Option B

SBRC Feedback

School Boundary Review Criteria

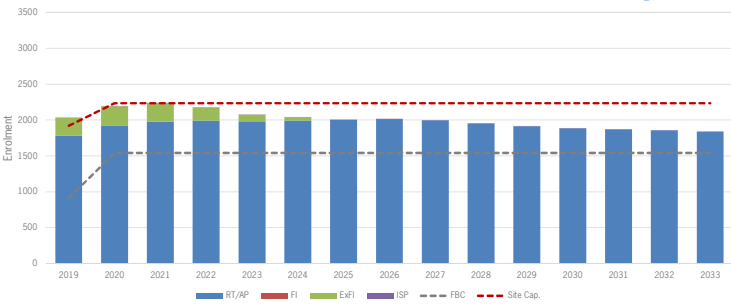
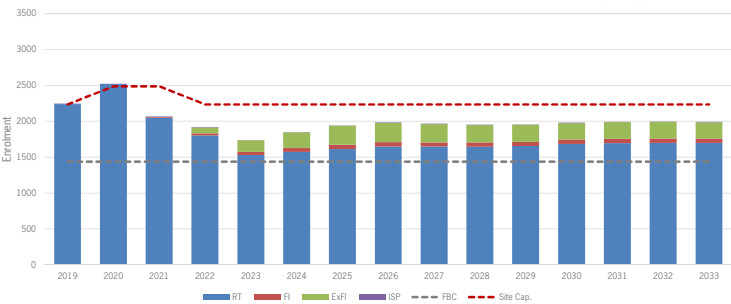
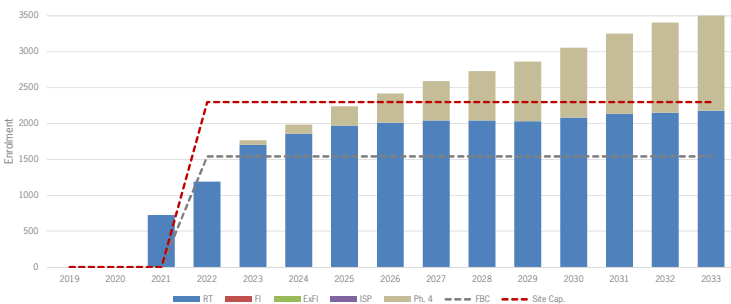
NO	SOME WHAT	YES
1. Optimize the use of existing school facilities?		✓1	✓2
2. Minimize the use of portable classrooms?	✓2		✓2
3. Minimize school boundary adjustments over the long-term?	✓2		✓1
4. Maximize walkers to school and minimize transportation needs?	✓2	✓1	
5. Ensure that school populations are sustainably sized?			✓3
6. Give due consideration to the concept of neighbourhood and Catholic school communities?	✓1	✓1	✓1

- More in keeping with Parish boundaries ✓✓
- Ex French is at an existing school
- Clean division

- High use of portables
- Many schools have to travel further / increase busing ×
- Impacting 2 largest schools
- Only SAOP is being impacted
⇒ QoH also impacted

- Keep SAOP at BR ⇒ too far ✓
⇒ (Option D + A)
